<b>SB Number:</b>	<b>SB 2BX-002</b>	<b>Creation Date:</b> 01/03/2004
<b>Subject:</b>	MPF paper jams	
<b>Model:</b>	FS-1010, FS-1050

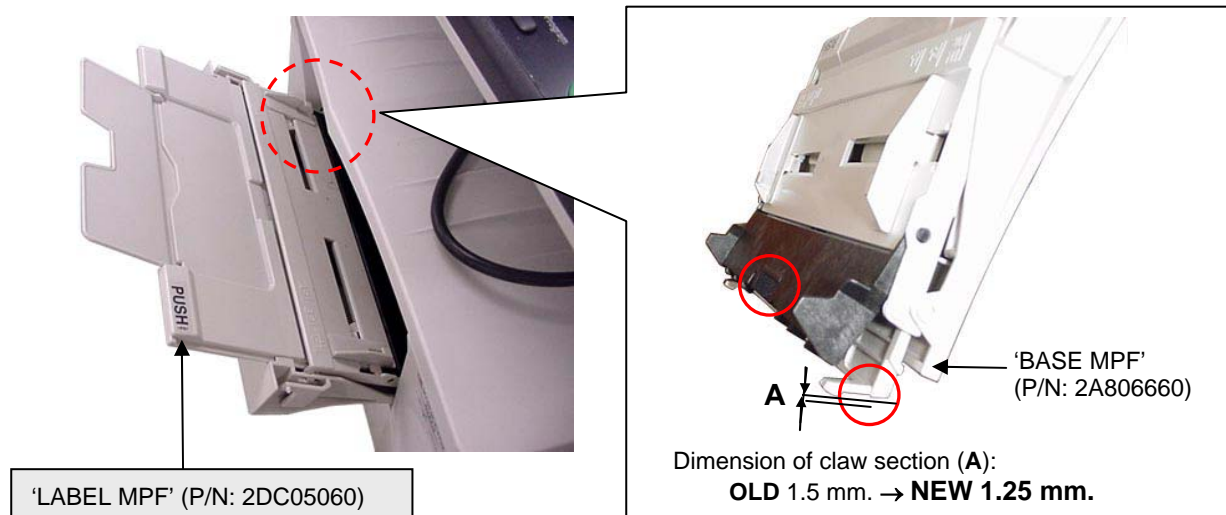
Please instruct and/or assure the user to press the MPF tray, '**PUSH SEAL**' (P/N: 2DC05060), hard until a click is heard before placing the paper.

The dimension of claw for 'BASE MPF' (No.1) has been shortened so that the MPF section can be easily opened with weaker force than before.
